**MONTGOMERY COUNTY HISTORIC PRESERVATION COMMISSION**  
**STAFF REPORT**

<b>Address:</b>	51 Elm Ave., Takoma Park	<b>Meeting Date:</b>	9/17/2025
<b>Resource:</b>	Contributing Resource <b>Takoma Park Historic District</b>	<b>Report Date:</b>	9/10/2025
<b>Applicant:</b>	Aleksandra Johnson & Mark Murray Brian McCarthy, Architect	<b>Public Notice:</b>	9/3/2025
<b>Review:</b>	Historic Area Work Permit	<b>Tax Credit:</b>	n/a
<b>Permit Number:</b>	1098627	<b>Staff:</b>	Dan Bruechert
<b>Proposal:</b>	Partial Demolition and Construction of Rear Addition, Screen Porch, and Exterior Stair

*Figure 5: Proposed left side (east) elevation.*

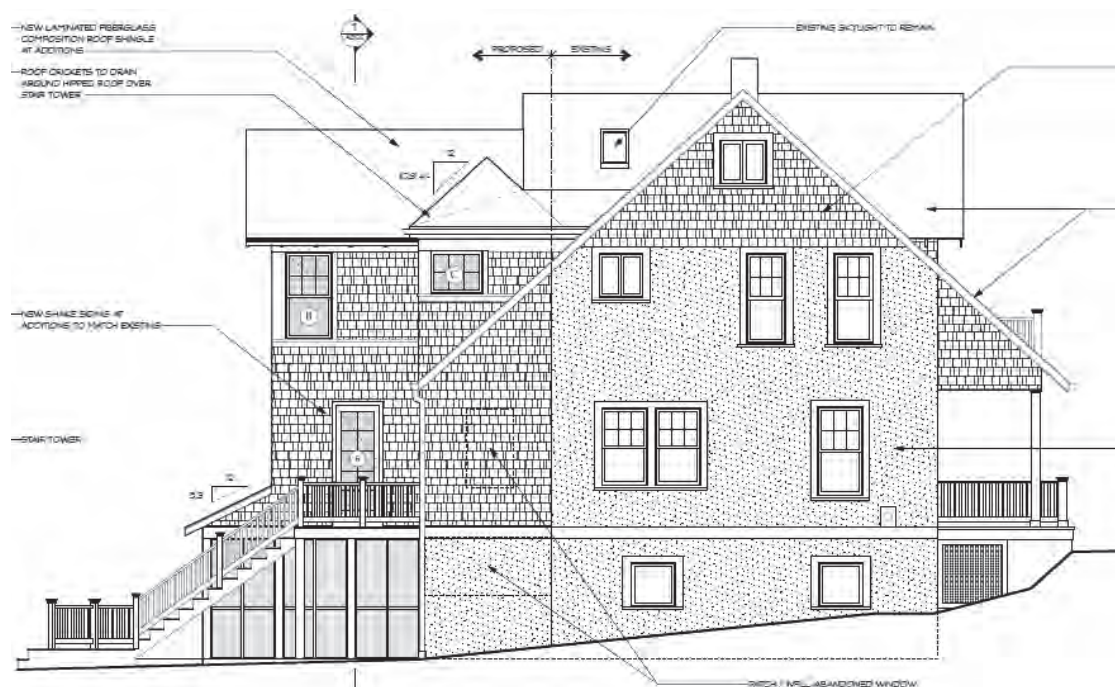
Beginning at the basement, the applicant proposes to alter the existing fenestration in the basement sunroom. The windows on the left (east) elevation will be removed as will the French doors and one window on the rear (south) elevation. On the first floor, the applicant proposes to demolish most of the existing walls and windows, but will retain the existing wall on the left (east) and the left-rear (southeast) corner. On the second story, the applicant proposes to demolish all of the existing enclosed sleeping porch.

The basement's rear door will be relocated so it is centered on the elevation. This relocation will accommodate the construction of a new wall along the left (east) elevation to accommodate the new staircase.

*Figure 6: Proposed rear elevation.*

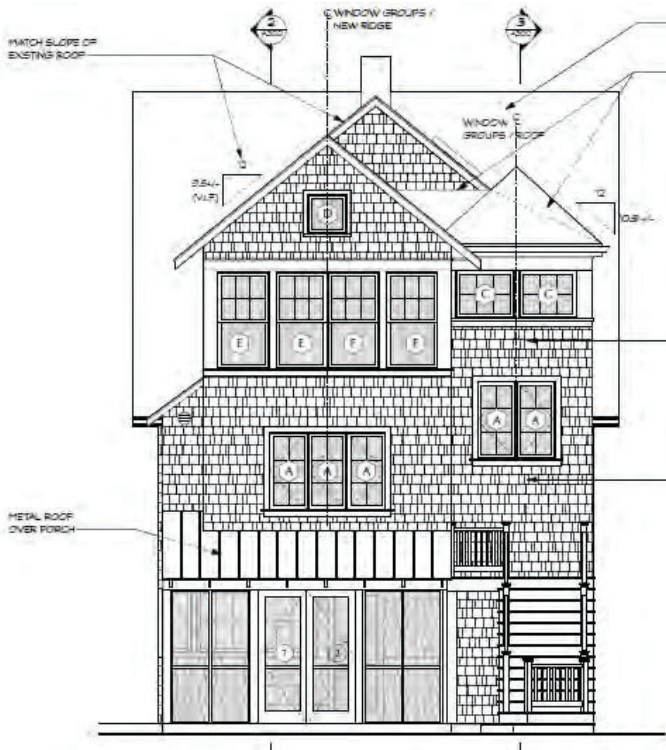
On the first and second stories, the applicant proposes to construct a rear addition that will project an additional 4' 6" (four feet, six inches) from the rear of the existing house and measures 12' 6" (twelve feet, six inches) wide with a rear gable roof with exposed rafter tails. The proposed staircase will widen the second story by approximately 2' (two feet) to the left (east) to be co-planer with the existing gable end and will have a hipped roof (see *Figure 6*, below). Because the addition utilizes the existing enclosed porch footprint, the proposed addition will have a nominal inset, not the 1' (one foot) the HPC typically requires.

The exterior of the addition will be covered in wood shakes to match the existing rear elevation. Proposed windows and doors will be a combination of aluminum clad wood Weathershield casement and sash windows. Exterior doors will be wood. The applicant identified the proposed window material but has not identified a window specification at this stage. The proposed gable and hipped roofs will be covered with architectural shingles.

The proposed addition will be partially visible from the public right-of-way from Westmoreland Ave. when considered in the absence of vegetation (see *Figure 7*, below).

The addition will be visible from the right-of-way; however, the rear elevation has been substantially altered from its historic form already. Staff finds the proposed modestly sized addition will not have a significant impact on the character of the surrounding streetscape as required in the *Design Guidelines*.

Staff's primary concern regarding the compatibility of the proposed addition was the lack of an inset, particularly on the right (west) elevation. In the discussion at the Preliminary Consultation, the HPC unanimously supported the proposed inset because the addition was extending from an existing modified wall plane. A minority of the commissioners encouraged the applicant to attempt to increase this setback, even though they were supportive of the justification provided by the application. Staff concurs with the commissioners finding that the minimal setback is appropriate and recommends the HPC approve the two-story addition under *Design Guidelines*, 24A-8(b)(2) and (d), and *Standards #2* and *9*.

2 PROPOSED FIRST FLOOR PLAN

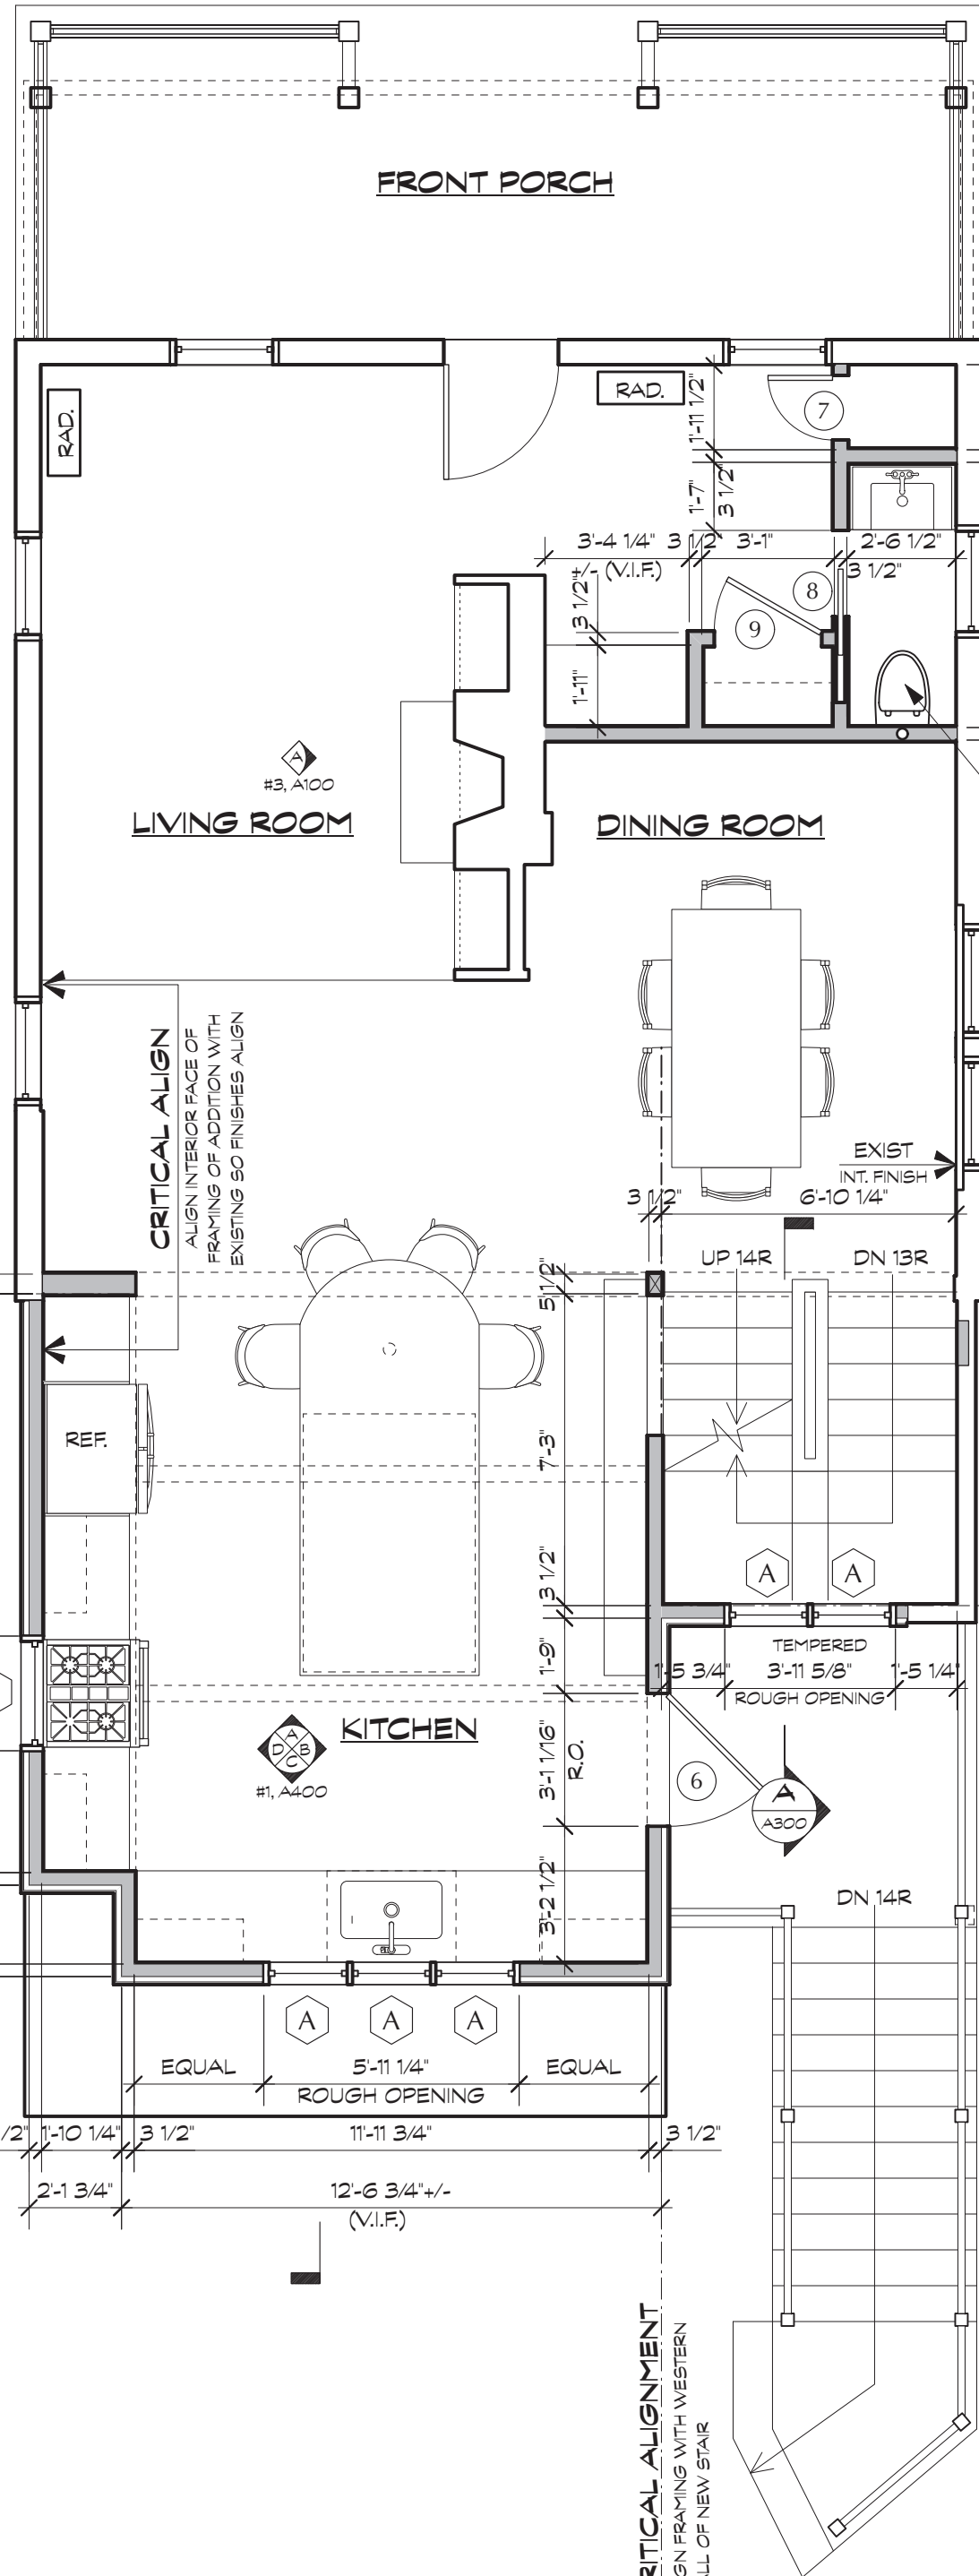
A commissioner noted there was an error in the first floor plan drawings showing a window on the east side of the proposed stair tower.
